**THE
NATIONAL
BOARD**
OF BOILER AND
PRESSURE VESSEL
INSPECTORS

NATIONAL BOARD INSPECTION CODE COMMITTEE

MINUTES

Meeting of July 18th, 2019
Kansas City, MO

FIGURE 3.3.4.6-a
FLUSH PATCH CONFIGURATIONS IN UNSTAYED AREAS

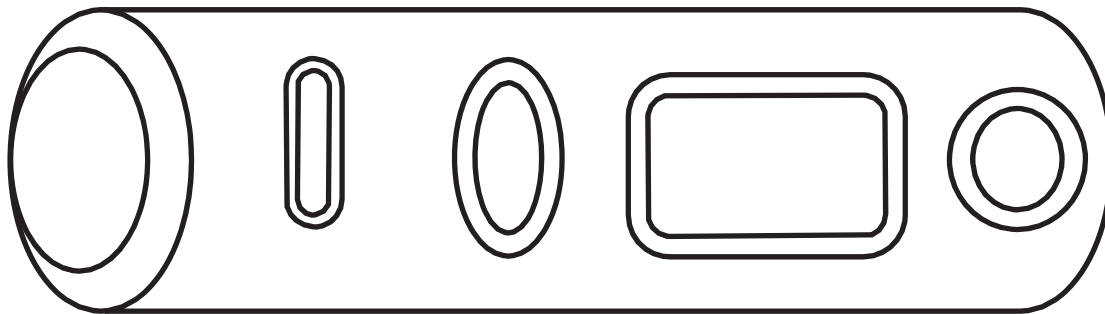
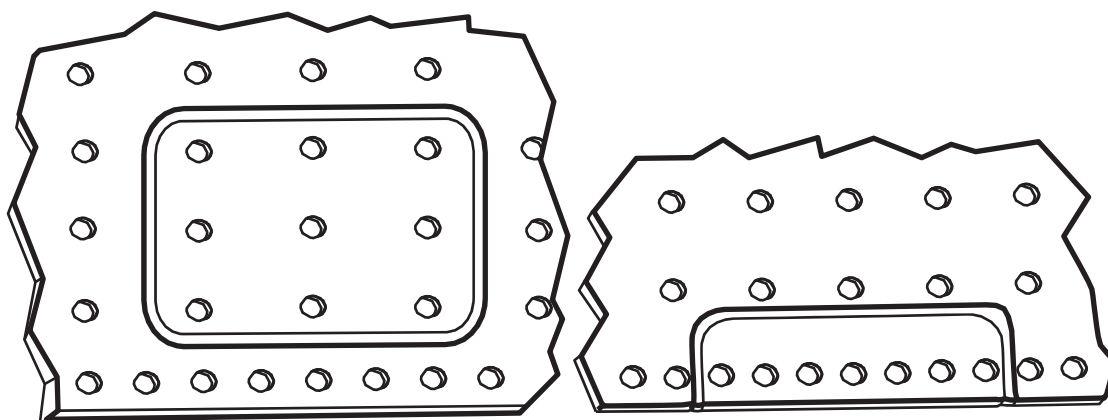
- 1) The weld around a flush patch shall be a full penetration weld and the accessible surfaces shall be ground flush where required by the applicable original code of construction. Examples of flush welded welded flush patches are shown in NBIC Part 3, Figure 3.3.4.6-a. ~~The welds shall be subjected to the nondestructive examination method used in the original code of construction or an alternative acceptable to the Inspector~~ and, where required, the Jurisdiction. Nondestructive examination will be performed in accordance with the requirements from NBIC Part 3, Section 4.2.

In some situations it is necessary to weld a flush patch on a tube, such as when replacing tube sections and accessibility around the complete circumference of the tube is restricted, or when it is necessary to repair a small bulge. This is referred to as a window patch. Suggested methods for window patches are shown in NBIC Part 3, Figure 3.3.4.6-b.

FIGURE S2.13.14.3-a
FUSIBLE PLUG REPAIR USING HALF COUPLING

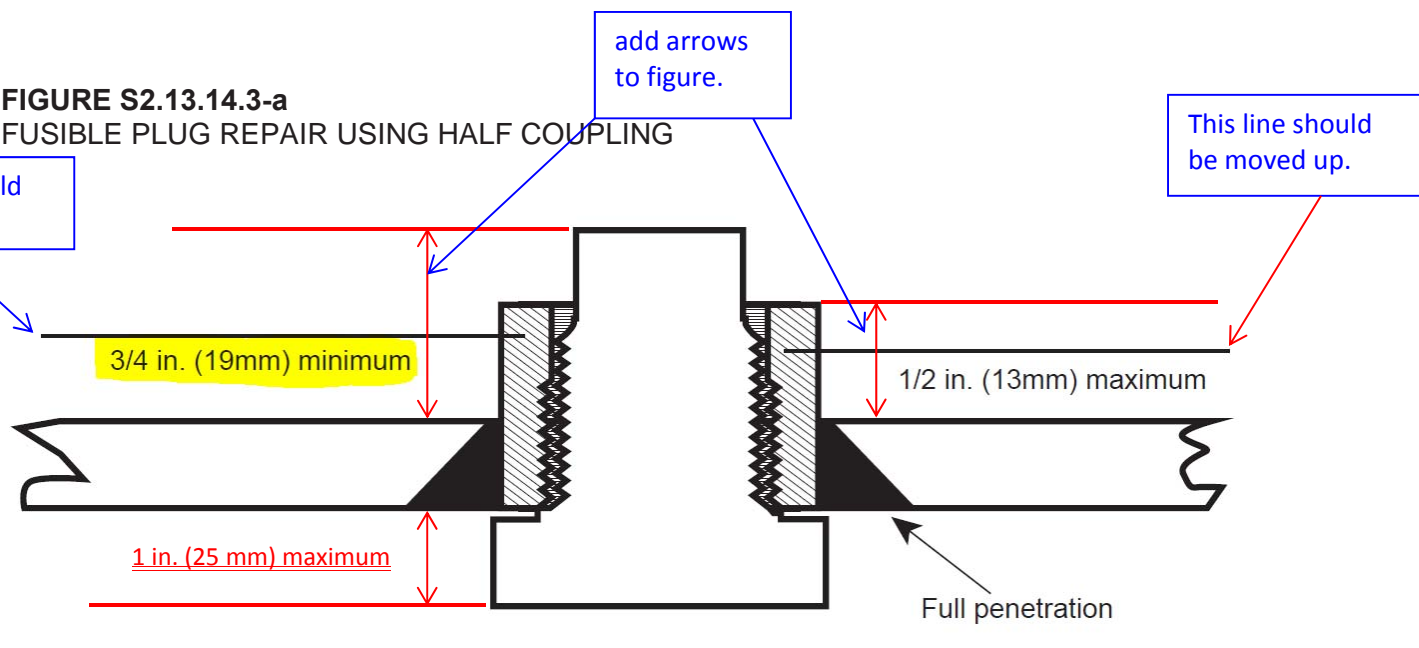
Item Number: 19-27	NBIC Location: Part 3, S2.13.14.3-a	Attachment Page 170
General Description: Fusible Plug Repair Using Half Coupling Figure		
Subgroup: SG Historical		
Task Group: J. Amato (PM)		
July Meeting Action: Mr. Troutt introduced the item and explained the change being proposed. A motion was made and seconded to approve the proposal as presented. After discussing the proposal, the committee felt that the item should be sent to letter ballot to allow for more time to consider the proposed changes.

- c) The half coupling connection shall be such a size as to not interfere with proper operation of the fusible plug. The half coupling shall be welded flush to the fire side using a full penetration weld. The half coupling must not project higher than 1/2 inch (13 mm) from the water side (See Figure NBIC Part 3, S2.13.14.3-a).

- d) Flush patch type repairs are to be installed in accordance with S2.13.9.3 and S2.13.10.3 (See Figure S2.13.14.3-b).
- e) A fusible plug shall be of such length that when installed it shall project at least 3/4 inch (19 mm) on the water side of the plate, tube, or flue. It shall extend through the plate, tube, or flue on the fire side as little as possible but not more than 1 inch (25 mm).

FIGURE 3.3.4.3-c
EXTERNAL OVERLAY TERMS AND DEFINITIONS

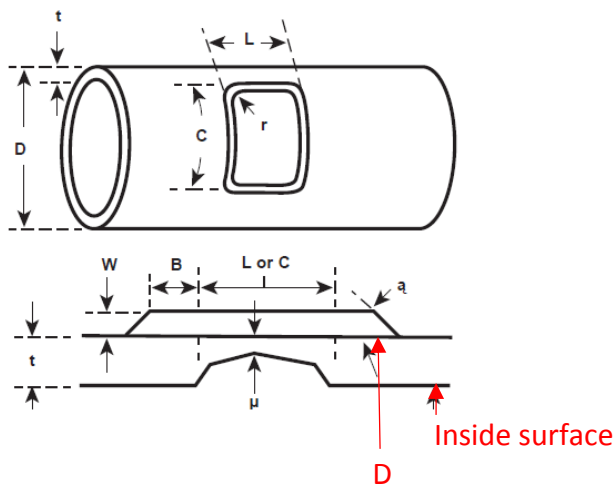
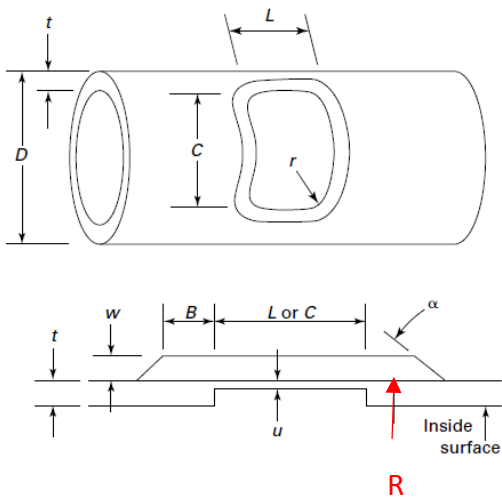
Issue: Is the maximum dimension (L , length along axis) not to exceed the lessor of $1/4$ or $1/2$ the nomimal outside diameter of the pressure component, or 8"?
